HISTORIC AND DESIGN REVIEW COMMISSION

November 07, 2018

HDRC CASE NO: 2018-525
ADDRESS: 115 DEVINE ST
LEGAL DESCRIPTION: NCB 723 (115 DEVINE SUBD), BLOCK 5 LOT 23
ZONING: IDZ CD
CITY COUNCIL DIST.: 1
DISTRICT: Lavaca Historic District
APPLICANT: Brian Voges/Voges Design, LLC
OWNER: Operative Holdings LLC
TYPE OF WORK: Construction of five, two story, multi-use structures
APPLICATION RECEIVED: October 12, 2018
60-DAY REVIEW: December 11, 2018
REQUEST:

The applicant is requesting conceptual approval to construct five, two-story, multi-use structures on the vacant lot at 115 Devine, located within the Lavaca Historic District.

FLOOR PLAN
SCHEMATIC DESIGN

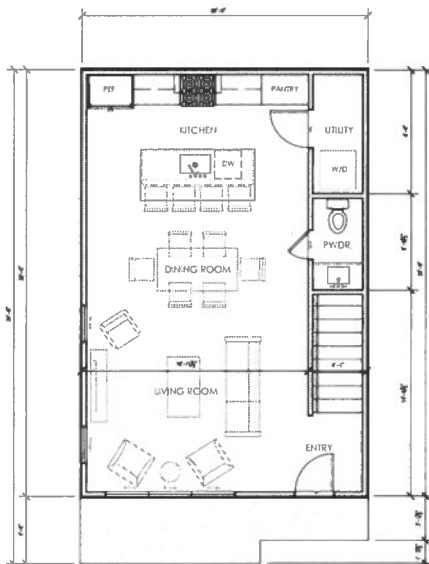
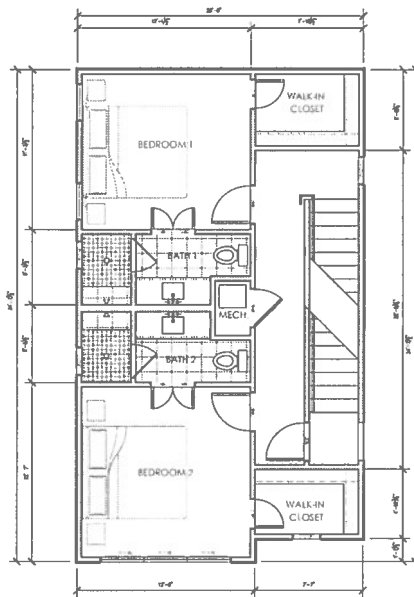
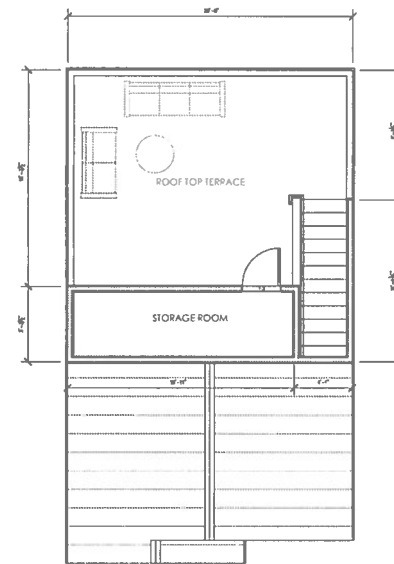
- ENTRANCES – According to the Guidelines for New Construction 1.B.i., primary building entrances should be oriented towards the primary street. The southernmost structure will feature an entrance that faces Devine Street. The two middle structures will feature entrances that face east, toward the side yard. The rear most structures will feature entrances that face toward to center of the lot and Devine Street. Typically, historic entrances are orientated towards the primary street. This is true for this particular block of Devine and the Lavaca Historic District. Staff finds the front unit's entrance orientation to be consistent with the Guidelines, but finds the orientation and entrances of the middle two units to be a departure from typical development patterns in the vicinity and throughout the district. Staff finds that a primary and secondary relationship between the proposed structures would be more consistent with the Guidelines.

- i. FOUNDATION & FLOOR HEIGHTS – According to the Guidelines for New Construction 2.A.iii., foundation and floor height should be aligned within one (1) foot of neighboring structure’s foundation and floor heights. The applicant has not specified foundation heights at this time. The applicant is responsible for complying with the Guidelines.

- j. ROOF FORM – The applicant has noted front facing roofs for each of the five structures to feature gables, while the rear of the structures feature a flat roof with a parapet wall for access to a rooftop deck. As proposed, the roofs present a combination that is not found historically in the district. Staff finds that the proposed flat roofs and parapet walls should be revised to better complement historic roof forms of the district.

- iv. That the applicant propose a foundation height that is consistent with the Guidelines as noted in finding i.
 - v. That the applicant eliminate the proposed flat roofs and incorporate a roof form that is complementary of those found historically in the district as noted in finding j.

- vi. That the applicant proposed architectural elements, particularly those pertaining to roof forms and front façade massing and arrangement that are complementary of the historic architectural elements and massing found in the district as noted in finding k.

DRAWN BY: BL/VOGES
DATE: 10/10/18
SCALE: NOTED
SHEET: A1.0

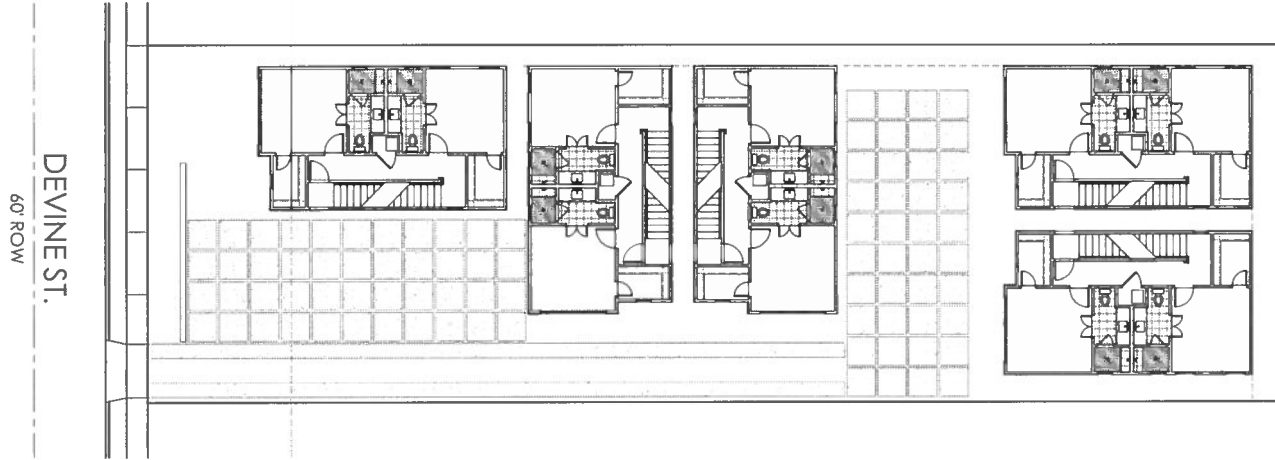
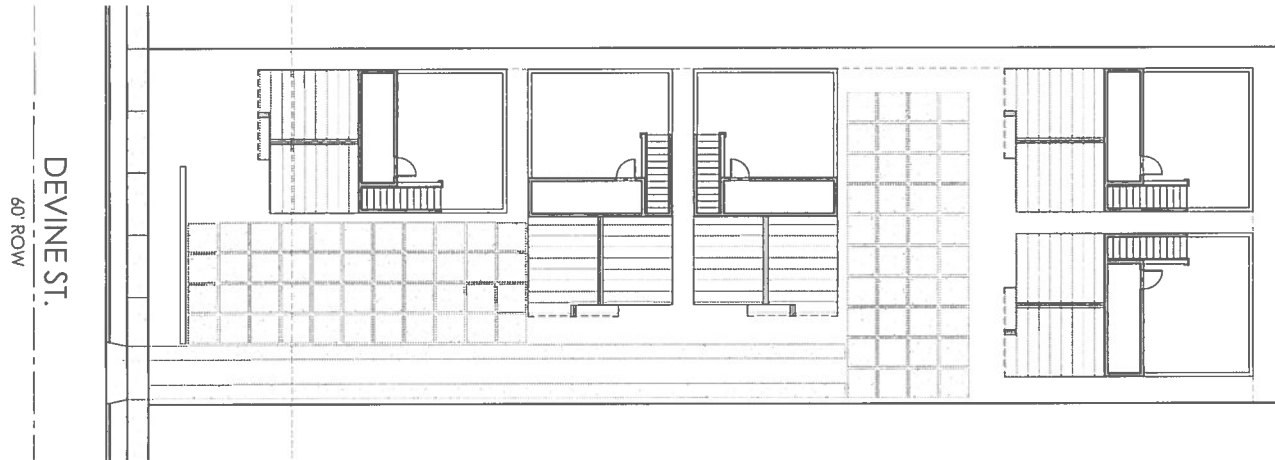
- BUILDING TO LOT RATIO – The Guidelines for New Construction 2.D.i., notes new construction should be consistent with adjacent historic buildings in terms of the building to lot ratio. The proposed building to lot ratio is not consistent with the Guidelines nor the historic development pattern found throughout the Lavaca Historic District.

- SETBACKS & ORIENTATION – According to the Guidelines for New Construction, the front facades of new buildings are to align with front facades of adjacent buildings where a consistent setback has been established along the street frontage. Additionally, the orientation of new construction should be consistent with the historic examples found on the block. The historic structures on this face of the block feature setbacks that range in depth from approximately twenty-three (23) feet to approximately thirty-one (31) feet. At this time, the applicant has not specified a setback from the street facing structure. Staff finds that a setback that is greater than those found historically on the block should be used. The proposed orientation for the street facing structure is consistent with the Guidelines; however, the middle structures, which feature an orientation toward the side yard are a departure from the typical development patterns in the vicinity and throughout the district.

- k. ARCHITECTURAL DETAILS – At this time, the applicant has provided perspectives noting massing and some architectural details. The applicant has proposed second level massing that extends forward of the first floor massing. This is atypical of the massing of two story structures found historically within the district. Two story, historic structures feature either a double height porch element with front facades sharing the same wall plane, or feature porches that are recessed behind protruding bays. Staff finds that the applicant should incorporate architecture elements and forms that are found historically in the district into the design.

- q. LANDSCAPING – The applicant has noted the location of landscaping materials to facilitate onsite parking, plant materials, and trees. Per the site plan, the majority of the site will feature new construction or hardscaping. The Guidelines for Site Elements 3.A.ii. notes that historic lawn area should not be reduced by more than fifty (50) percent. Non-lawn areas, such as planting beds or mulched locations should exist where they historically were found, such as along fences, walkways or drives. The proposed landscaping is not consistent with the Guidelines.

- i. That a building to lot ration that is more consistent with that found historically in the district and the Guidelines be proposed as noted in finding e.
- ii. That the applicant proposed a front setback that is greater than the setbacks of the historic structures on the block

- ix. That all mechanical equipment be screened from view from the public right of way as noted in finding n.
 - x. That a landscaping plan be submitted that is consistent with the Guidelines as noted in finding q.
